工程指示 / 要求簡箋 ENGINEER INSTRUCTIONS(E.I.)

工程指示編號:	EI- 4631	修改版本:	A
	HK-0714		
工程編號:	J 858	工程名稱:	將軍澳日出康城11
收件人:	生統 / 楊榮輝 / .Maggie	發件人:	Ant Yeung
工程項目:	幕牆 單元件 香檳金膠 廠用配件BM	日期:	29/04/2022

Subject **Material Submission – Midi – Submission of Color Sample for Dowsil 791 (Tailor - Made Silver Champagne) & (Grey) (MS024)**

**Re: Design, Supply and Installation of Curtain Wall, Glass Wall, Aluminium Window, Aluminium Cladding, Aluminium Louvres and Glass Balustrade Nominated Sub-Contract at T.K.O.T.L. 70 RP, Phase 11, LOHAS Park, Tseung Kwan O, N.T. Submission of Color Sample for Dowsil 791 (Tailor - Made Silver Champagne) & (Grey) (MS024)**

① Interface between mullion and transom (inside.)

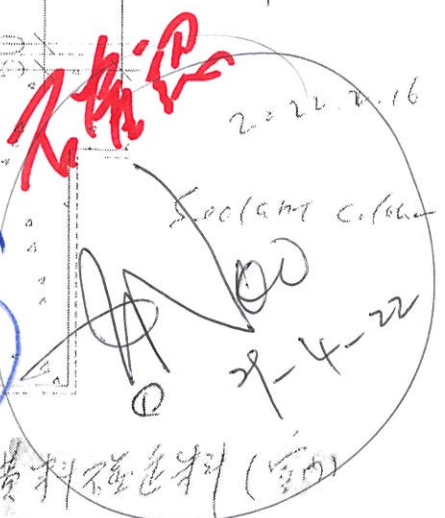
香橙金 silver champagne  
silver champagne sealant - location 1

Standard colour confirmed to be grey. Please coordinate with Polyfair for confirmation.

silver champagne sealant - location 2

silver champagne sealant - location 3

silver champagne sealant - location 4

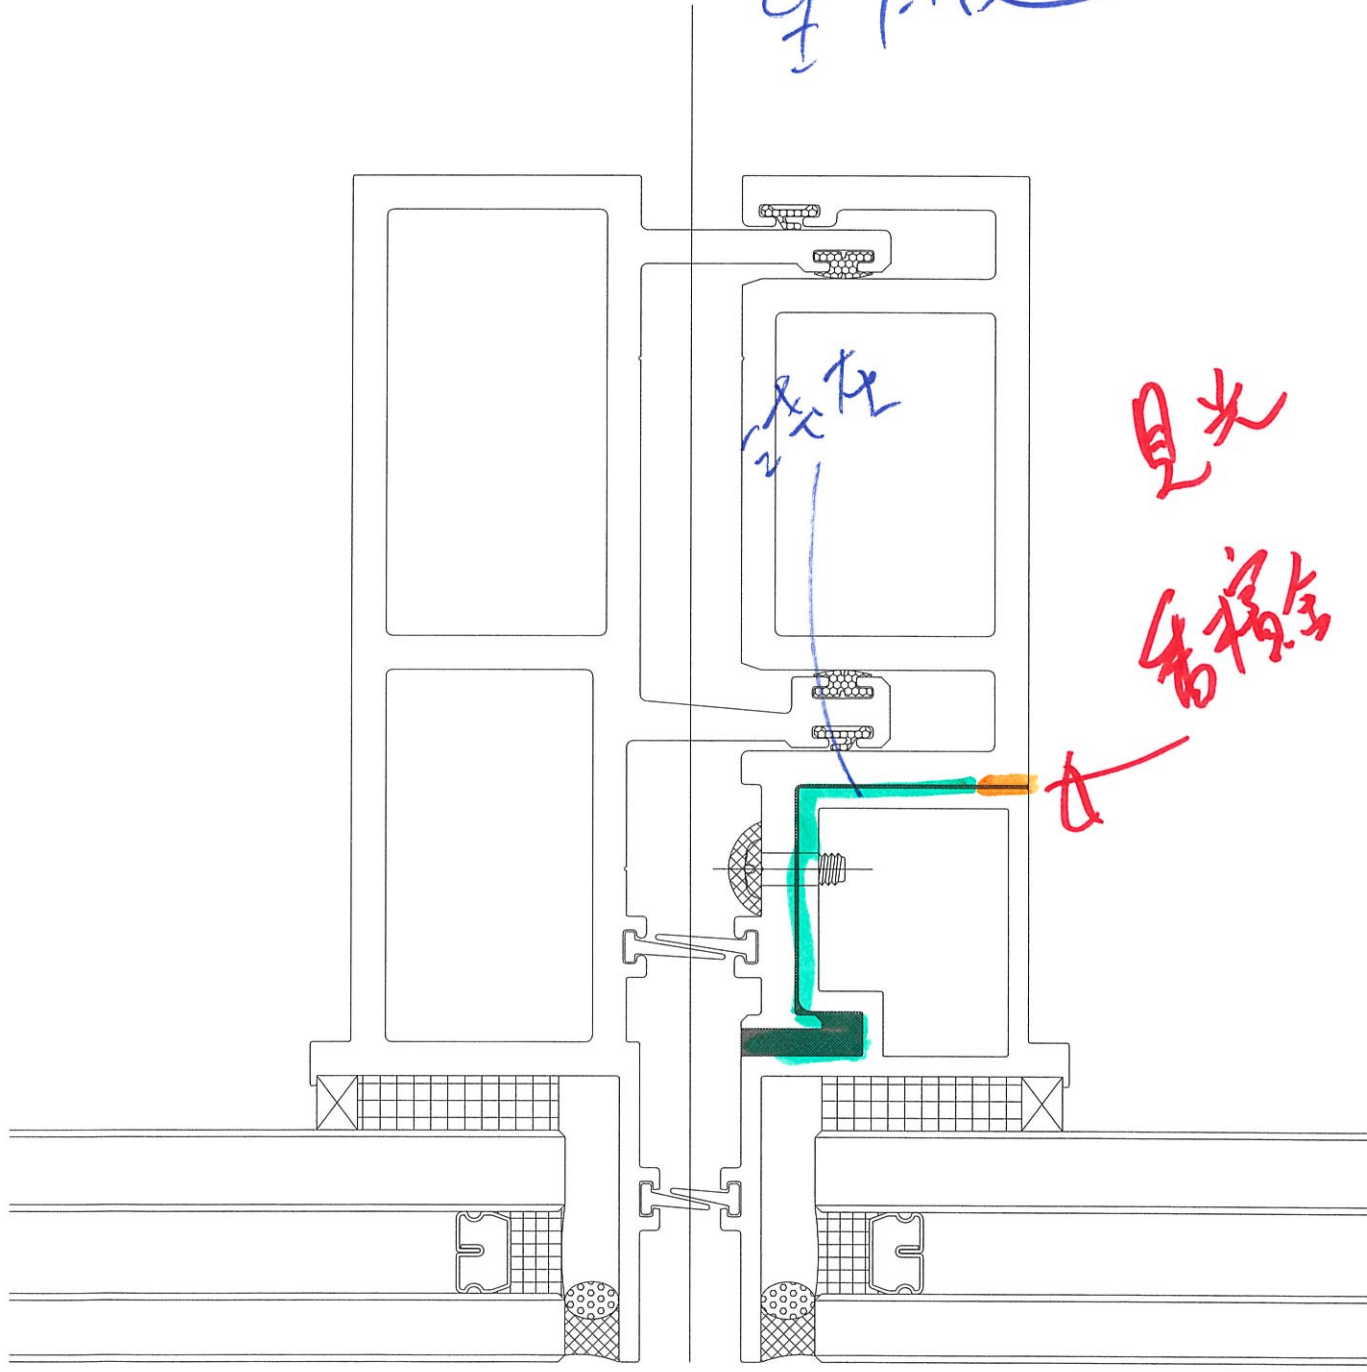
本工程用  
香橙金色胶  
和深灰色胶

Reply from R...  
3 March 2022
